RE: Zimmerman Road Extension of the Town of Fallsburg  
Consolidated Water District

We have reviewed the New York State Department of Health (NYSDOH) review letter dated November 17, 2017 for the above project and offer the following to supplement your response to the NYSDOH. The item numbers correspond to the NYSDOH review letter.

**METER/BACKFLOW PREVENTER VAULT**

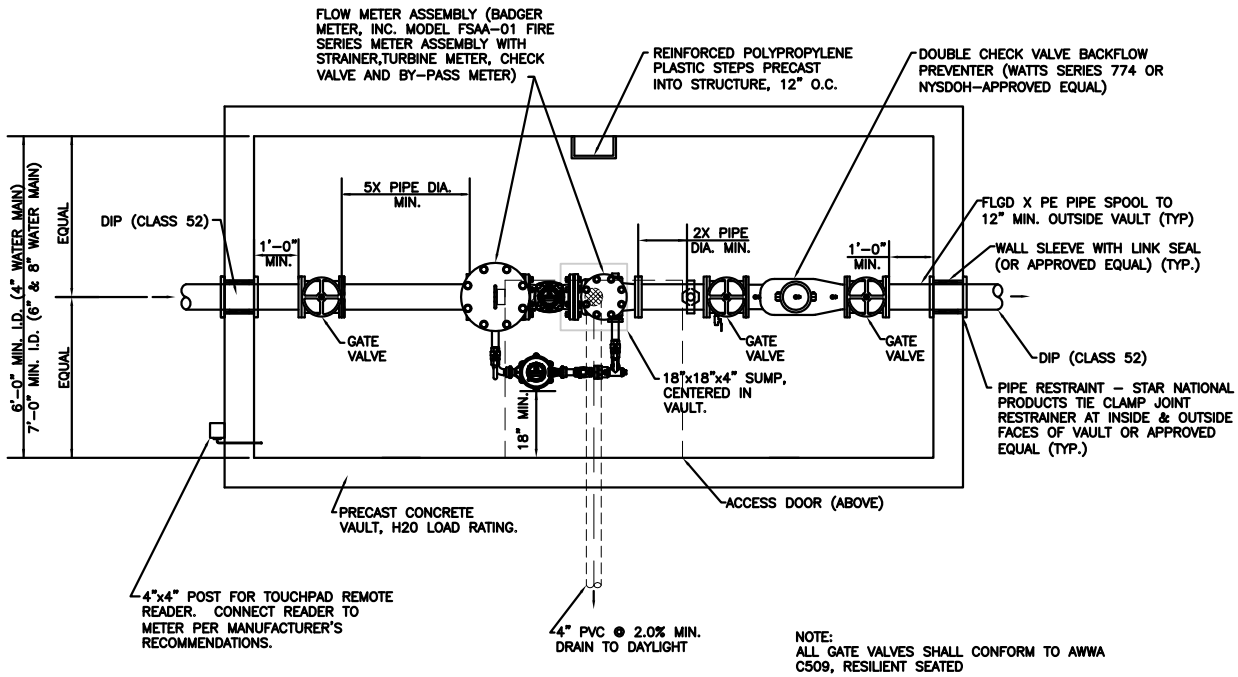
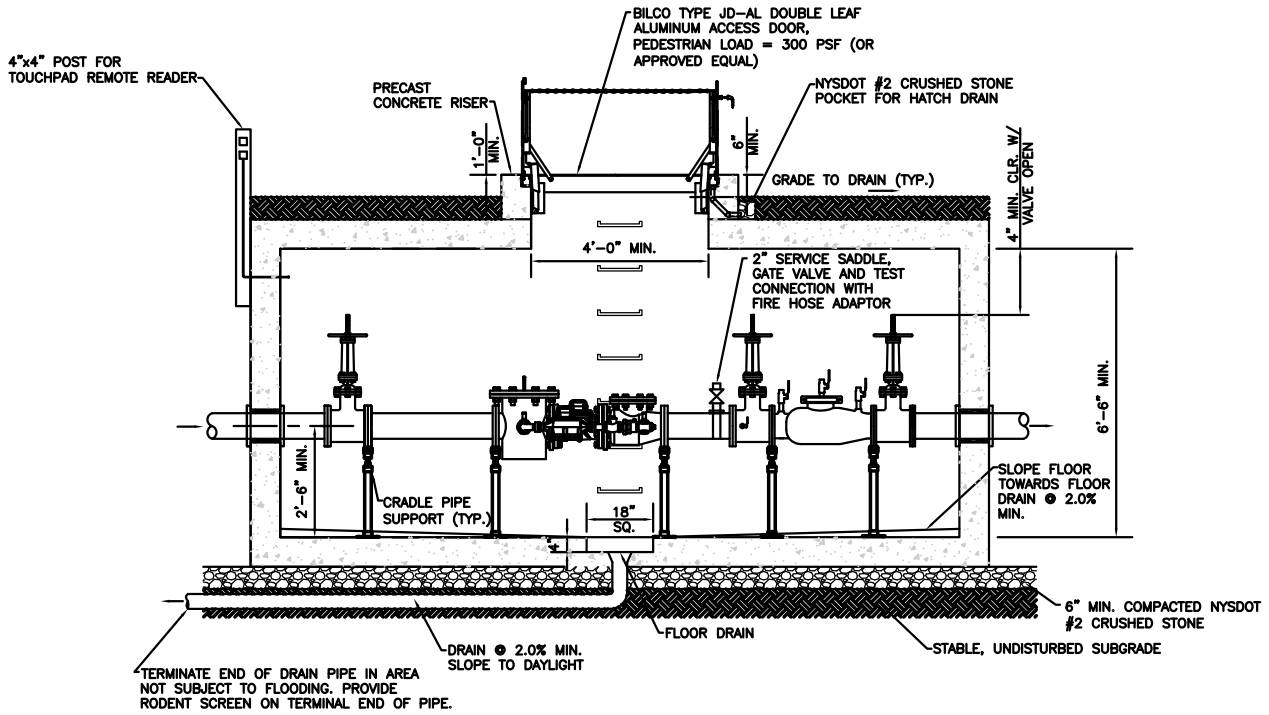
4. As you are aware, the detail for the meter vault is included with the project plans which were a separate submission to the Town. However, since the acceptance of the plan the Town has selected a Badger Meter in place of a Sensus meter. Attached please find a revised detail.
8. Attached please find a revised Specification Section 33 11 13 with the revised formula.
9. Attached please find Specification Section 33 13 00.
10. The attached Specification Section 33 11 13 is revised as requested.
11. Attached please find Specification Section 33 12 13.
12. Attached please find Specification Section 01 40 00.
